REMARKS

Claims 1, 4-8, 10, 11, 15 and 16 are pending in the present application. Claim 1 has been amended and claim 12 has been canceled by the present Amendment.

FIG.2
RELATED ART

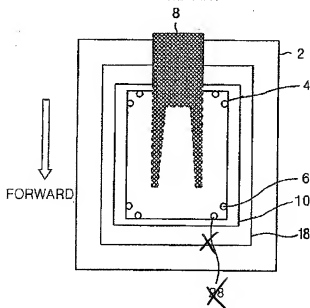
Regarding the rejection of claims 1, 4-8, 10-12, 15 and 16 under 35 U.S.C. § 112, second paragraph, it is respectfully noted Figure 2 has been amended to remove the label 28 (i.e., a stopping pin) because it is clear the pointed to element is a lift pin 6 and not a stopping pin 28. Figure 3 properly illustrates the location of the stopping pins 28 used to stop the substrate 4.

FIG. 5

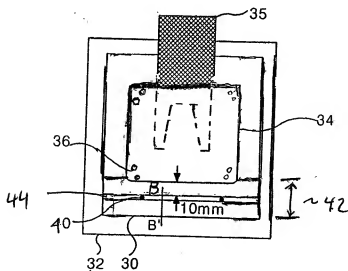
Regarding the objection to the drawings, it is respectfully noted Figures 2, 3, 5, 6, 12A and 12B have been amended to address the concerns noted in the Office Action. For example, Figure 5 has been amended to clearly show the sliding portion 42 disposed at one edge of the susceptor 30. Figures 11A-11C also clearly show the sliding portion 42. Figure 6 has also been amended to show a length of the sliding portion 42, measured from the groove 44, is about 10 mm. Figure 5 already shows this dimension of 10mm for the sliding portion 42. Note, this dimension is particular advantageous because this dimension makes a transfer of the substrate 34 more stable than the background art dimension of only 5mm (see paragraph [0041] in the originally-filed specification). In addition, because the dimension of the sliding portion is 10mm, the substrate 34 stably slides along the sliding portion 42. This sliding action, although beneficial because there is a more stable transfer, results in a problem that excess material from

In addition, regarding the objection to Figures 12A and 12B only showing less than half of the susceptor, it is respectfully noted Figures 12A and 12B are partial views of the susceptor and are not intended to show the entire susceptor (Figure 5 illustrates the entire susceptor from a top view perspective). In addition, it is respectfully noted that the stepped-portion of the susceptor 30 (Figures 6-10 clearly illustrate the stepped-portion) occurs at only one edge of the susceptor and is not around an entire circumference of the susceptor.

FIG. 6

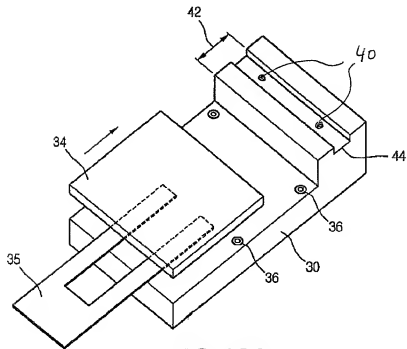
Thus, as shown in Figures 11A-11C, 12A and 12B, the robot arm 35 supports a portion of the glass substrate 34 with a non-supported edge portion freely hanging over the robot arm 35 such that as the robot arm 35 moves in a forward direction to transfer the glass substrate 34 onto the susceptor 30, the non-supported edge portion of the glass substrate 34 slides on the sliding portion 42 of the susceptor 30 and is stopped by at least one stopping pin 40 located at the stopping position. These figures also illustrate the groove 44 formed in the sliding portion 42 of the susceptor 30 at a location of the at least one stopping pin 40 for receiving material 45 resulting from sliding of the glass substrate 34 on the sliding portion 42 of the susceptor 30. Figures 5 and 6 also illustrate a length of the sliding portion 42, measured from the groove 44, is about 10 mm.

FIG.12A

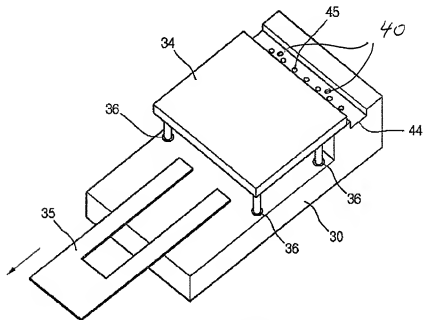
The present invention solves the problems of the related art by increasing the sliding portion of the susceptor to about 10mm and also by including a groove 44 in the susceptor 30 to catch scraped off material (Figure 11A-11C illustrate the material 45 being scraped off by the sliding substrate 34 and scraped into the groove 44). In addition, the stopping pins 40 are placed within the groove 44 (Figures 12A and 12B have been amended to clearly illustrate this feature). Note that original Figure 5 illustrates the stopping pins 40 being within the groove 40, and thus the amendments made to Figures 12A and 12B are not new matter.
